Enclosed please find a parcel lay-out of the planned well location in accordance with the septic tank.

HOWARD COUNTY HEALTH DEPARTMENT

RE: File Number: WP-99-139
Title: Ferron Property

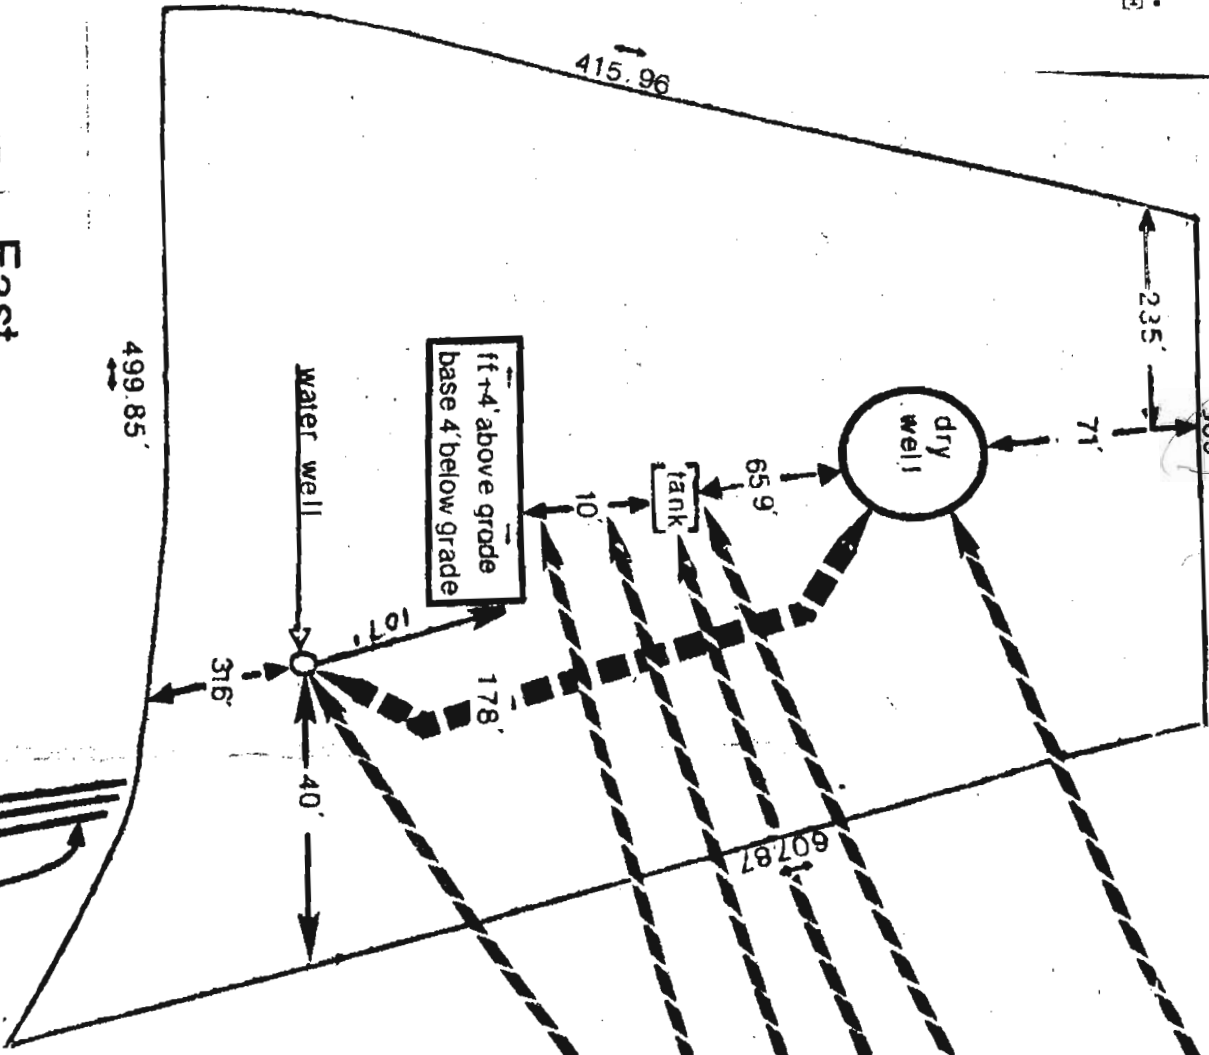
OK -
PLEASE ~~BUY~~
CONTACT WELL DRILLER
~~WELL~~ AND SUBMIT
PERMIT APPLICATION,
12/3/93
C. Williams

LOT OR PARCEL

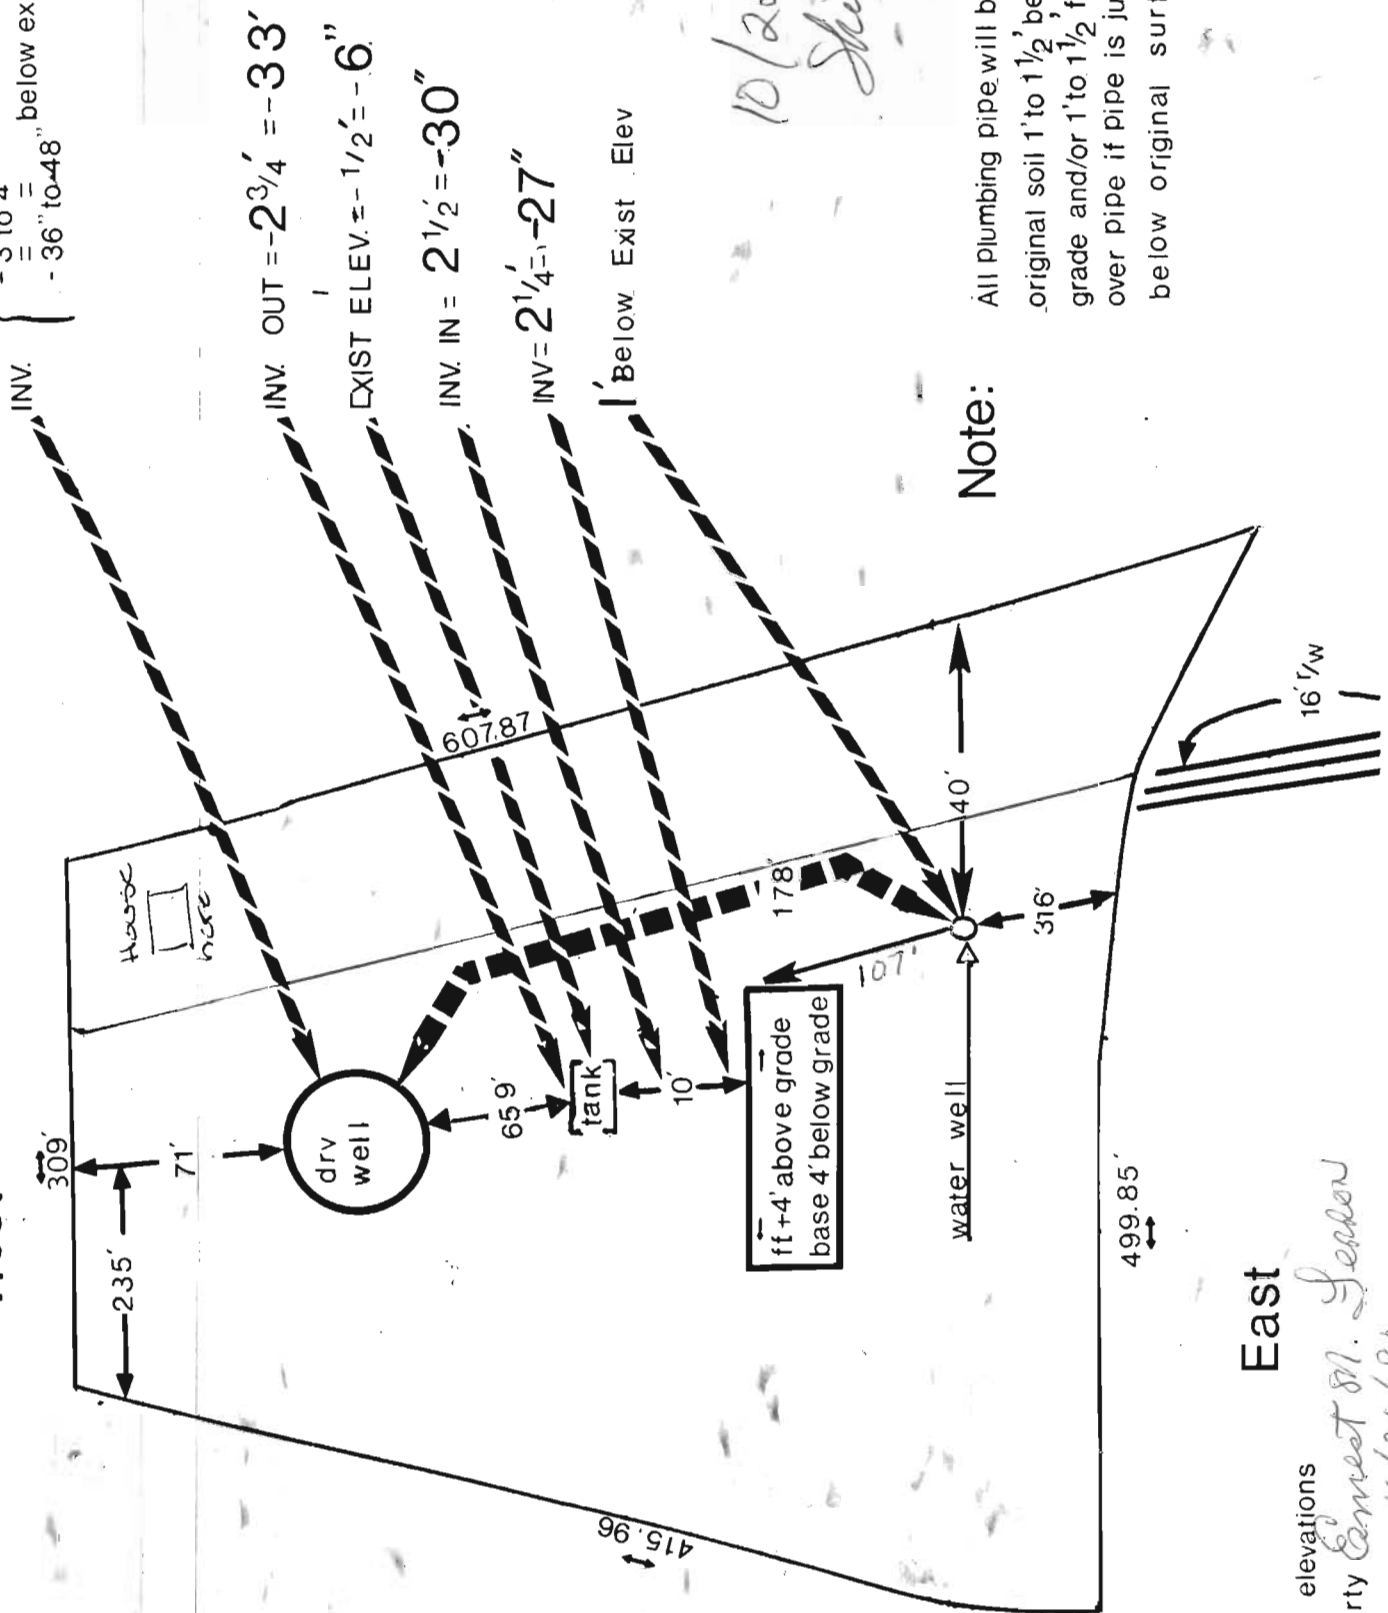
10/22/81
Sketch O.K.
G.S.
